South Texas Project Electric Generating Station P.O. Box 289 Wadsworth, Texas 77483

South Texas Project  
Unit 2  
Docket No. STN 50-499

Response to Request for Additional Information:  
Request for Relief from ASME Boiler and Pressure Vessel Code,  
Section XI Requirements for the Essential Cooling Water System  
(Relief Request RR-ENG-2-49) (TAC No. MD7495)

**SOUTH TEXAS PROJECT  
UNIT 2  
REQUEST FOR RELIEF FROM ASME BOILER AND PRESSURE VESSEL CODE,  
SECTION XI REQUIREMENTS FOR THE ESSENTIAL COOLING WATER SYSTEM  
(RELIEF REQUEST RR-ENG-2-49)**

FIGURE 1: LINE DRAWING OF ROCKWELL VALVE

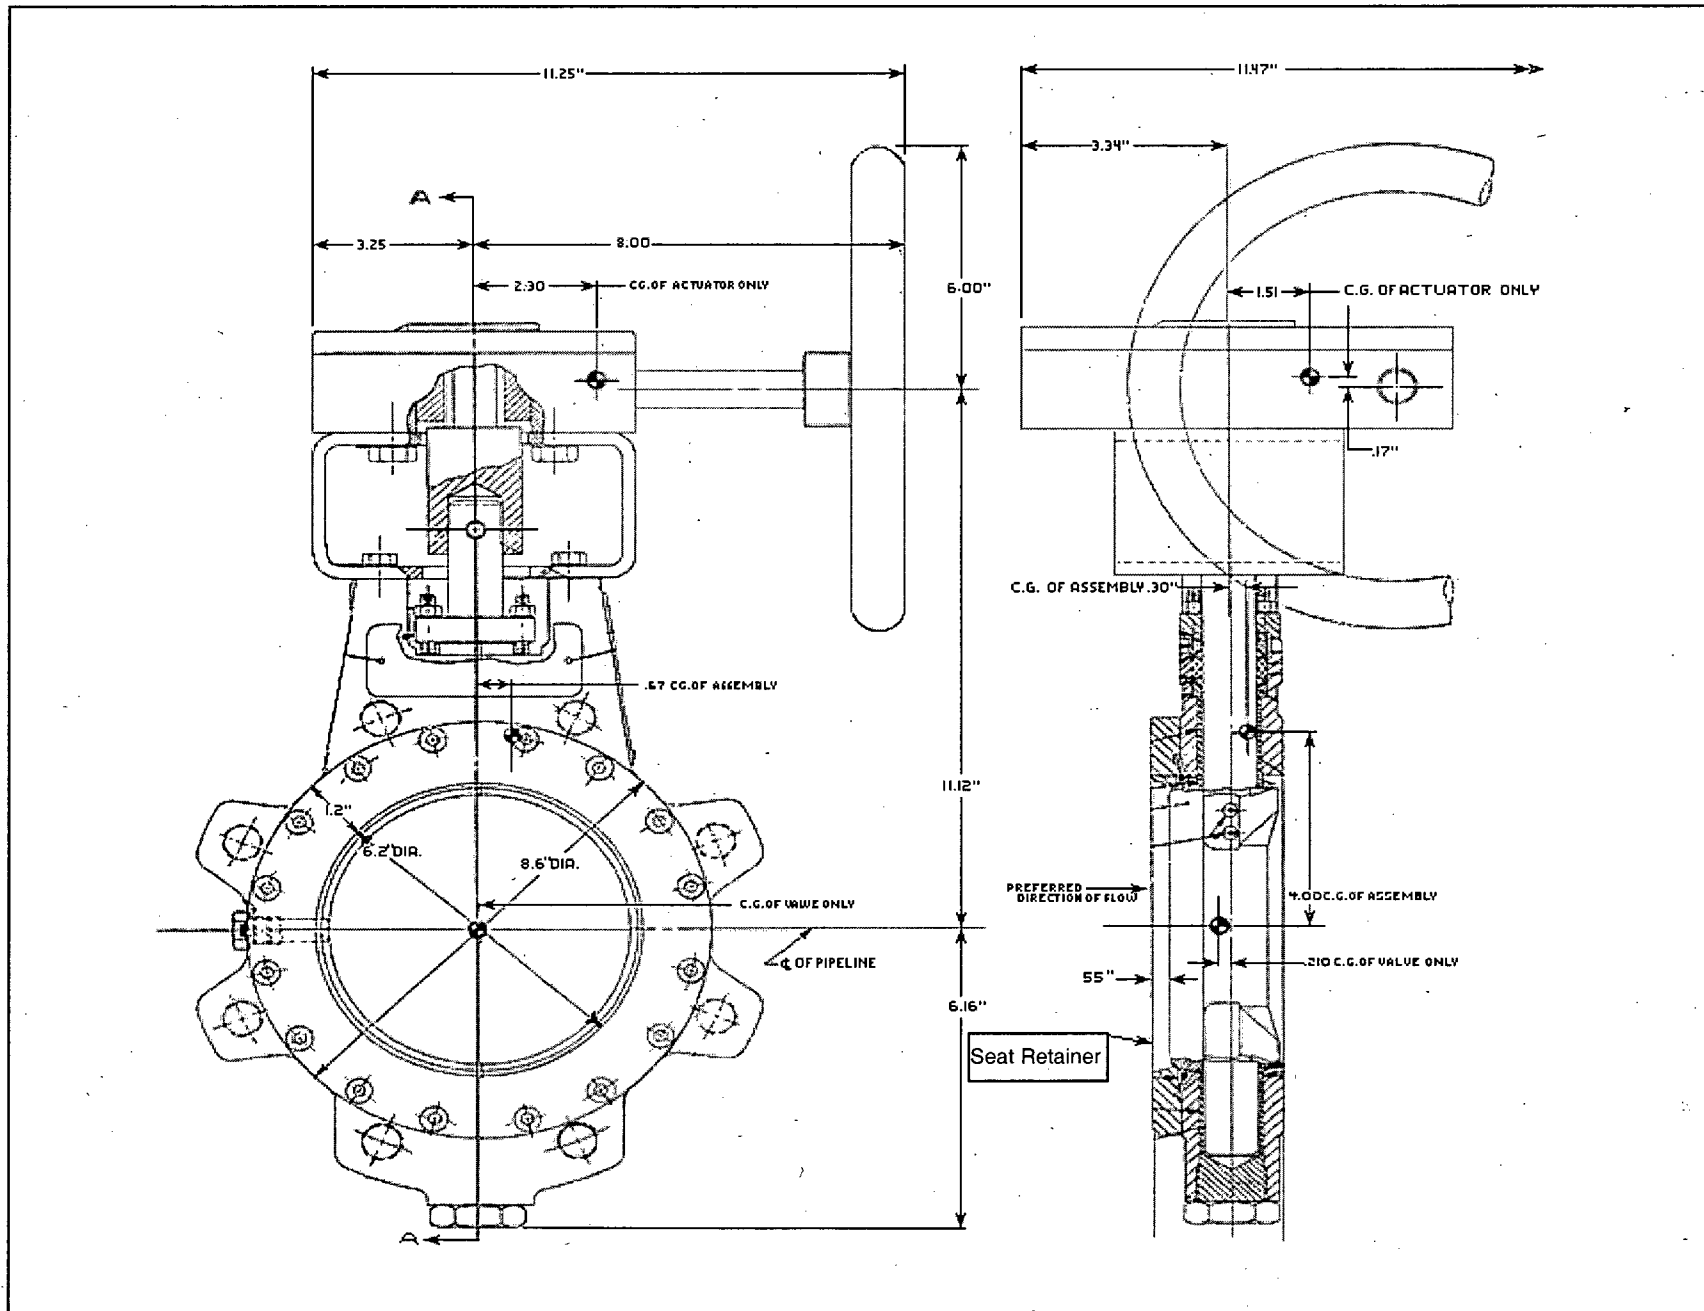
- (a) Provide a sketch to show how the seat retainer was connected to the valve 2-EW-0204 and the ECW piping.

- (b) Provide a sketch to show the dimensions of the referenced seat retainer (ID, OD, wall thickness and the length of component).

Figure 1 shows the configuration of the specific valve. Figure 2 is a typical representation of a valve showing how a seat retainer is installed. Figure 3 is a photograph of the actual valve showing its position relative to the attached ECW piping.

The dimensions of the parts illustrated in Figure 1 are as follows:

Outside diameter of seat retainer	= ~8.6"
Inside diameter of seat retainer	= ~5.9" to 6.2" (the ID is chamfered)
Thickness (radial) of seat retainer	= ~1.2" (the ID is chamfered)
Thickness (longitudinal) of seat retainer	= ~0.55"
